**SAN ANTONIO WATER SYSTEM
HIGHLAND ESTATES, UNIT 1 P.U.D. MONTANA PASS FLOATING GROUND
STORAGE TANK PROJECT**

**SAWS JOB NUMBER 15-1177
SOLICITATION NO. CO-00092**

**ADDENDUM NO. 5
October 13, 2016**

ANTENNA INSTALLATION DETAILS

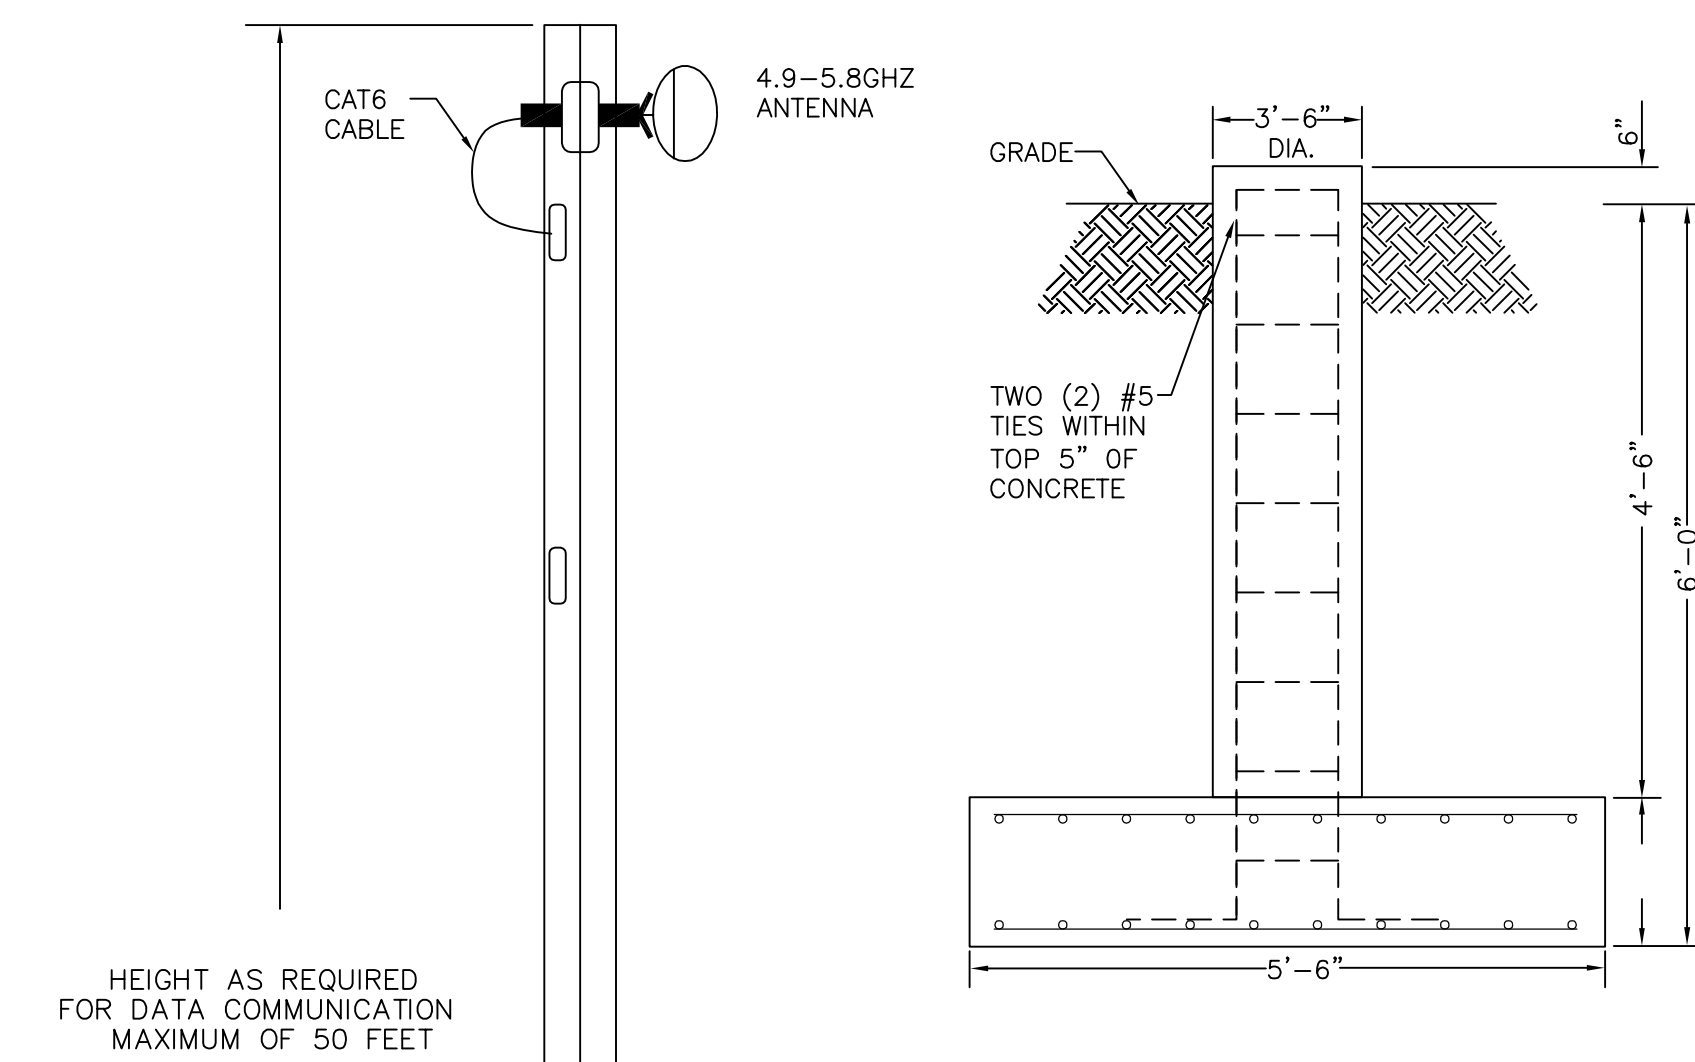
25. What are the specifics for the antenna pole?

Refer to E11 for detail and to Specification 17600 Antenna Tower.
